CUSTOMER NOTIFICATION

SUD-DT-04-0193 (1/11)

QB-V850ESSX2
(Control Code: A, B, C)

Operating Precautions

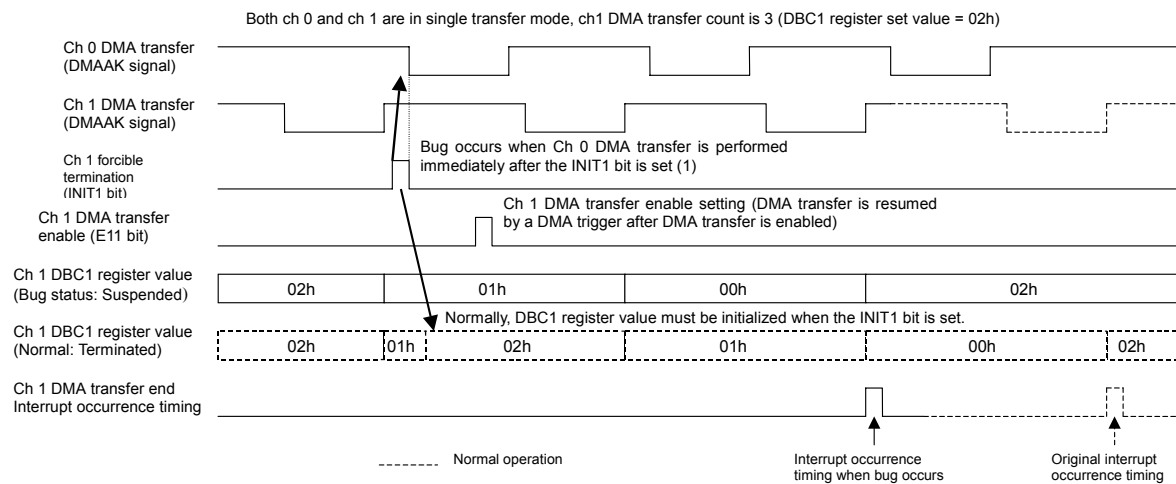
No.10 Bug related to DMA transfer forcible termination

When terminating a DMA transfer by setting the INITn bit of the DCHCn register, the transfer may not be terminated, but just suspended, even though the INITn bit is set (1). As a result, when the DMA transfer of a channel that should have been terminated is resumed, the DMA transfer will terminate after an unexpected number of transfers are completed and a DMA transfer completion interrupt may occur (n = 0 to 3). This bug occurs if a DMA transfer is executed immediately after a forcible termination is set (by setting the INITn bit) (see the figure below).

The following registers are buffer registers with a 2-stage FIFO configuration of master and slave. If these registers are overwritten during a DMA transfer or in the DMA-suspended status, the value is written to the master register, and reflected in the slave register when the DMA transfer of the overwritten channel is terminated.

The “initialization” in the above figure means that the contents of the master register are reflected in the slave register.

This bug can be avoided by implementing any of the following procedures using the software.

- <1> Disable interrupts (DI state).
- <2> Read the DMA restart register (DRST) and transfer the ENn bit of each channel to a general-purpose register (value A).
- <3> Write 00H to the DMA restart register (DRST) twice^{Note}.
By executing twice^{Note}, the DMA transfer is definitely stopped before proceeding to <4>.
- <4> Set (1) the INITn bit of the DCHCn register of the channel that should be terminated forcibly.
- <5> Perform the following operations for value A read in <2>. (Value B)
 - (a) Clear (0) the bit of the channel that should be terminated forcibly
 - (b) If the TCn and ENn bits of the channel that is not terminated forcibly are 1 (AND makes 1), clear (0) the bit of the channel.
- <6> Write value B in <5> to the DRST register.
- <7> Enable interrupts (EI state).

- <1> Copy the initial transfer count of the channel that should be terminated forcibly to a general-purpose register.
- <2> Set (1) the INITn bit of the DCHCn register of the channel that should be terminated forcibly.
- <3> Read the value of the DMA transfer count register (DBCn) of the channel that should be terminated forcibly and compare the value with the one copied in <1>. If the values do not match, repeat <2> and <3>.

4.1.1 Change of parts layout

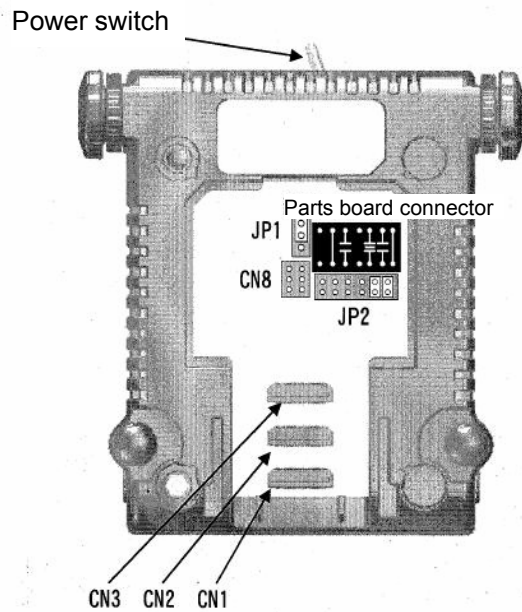
The parts layout has been modified in control code C or later as shown below.

This modification facilitates connection and disconnection of the parts board and jumpers.

Parts layout in control codes A and B

Parts layout in control code C

4.1.2 Modification of JP2 specification

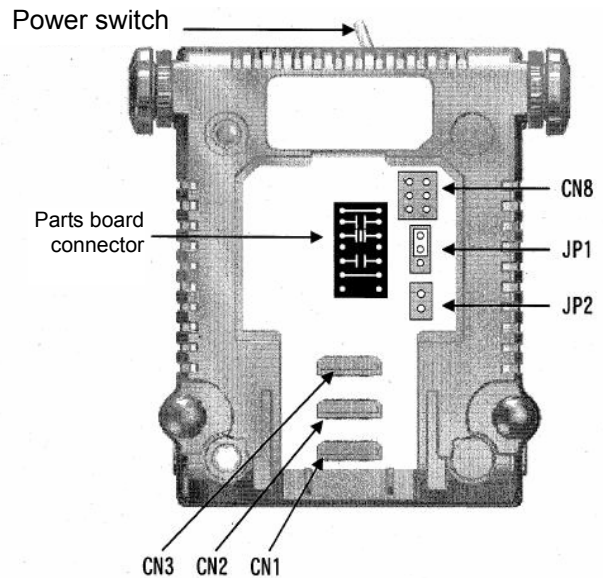
The JP2 specification has been changed as shown below.

JP2 in control codes A and B

JP2 in control code C

Use the default settings in control codes A, B, and C.
